**[Docket No. FAA-2016-9418; Product Identifier 2016-NE-23-AD; Amendment 39-19167; AD 2018-02-14]**

**Airworthiness Directives; Honeywell International Inc. Turboprop and Turboshift Engines**

**ACTION:** Final rule.

**Figure 1 to Paragraph (h) of this AD. Combustion Chamber Case Assembly**

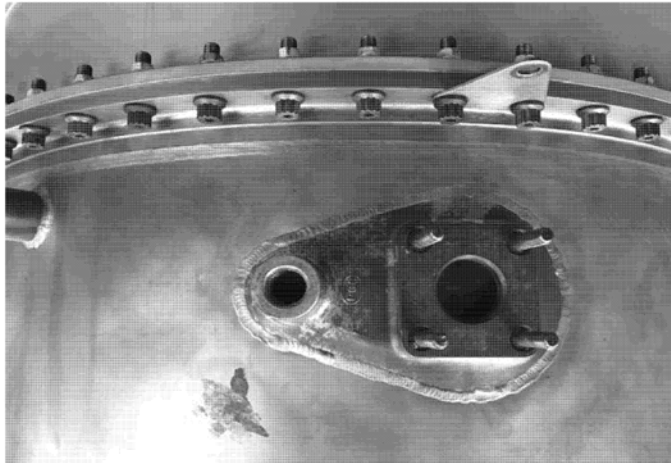
Perimeter Aviation LP (Perimeter) requested we add information to this AD regarding the number of failures of combustion chamber assemblies with or without the one-piece bleed pad. Perimeter requested further information on how these failures relate to the P/N 3101668-12 combustion chamber assembly.

We agree. We note that five of the six combustion chamber case assemblies that ruptured were assemblies without the one-piece bleed pad. P/N 3101668-x has the one-piece bleed pad with P3 boss, which demonstrated significantly reduced cracking between the P3 and bleed boss; therefore, this combustion chamber case assembly is not affected by this AD. No further changes are needed. We did not change this AD.
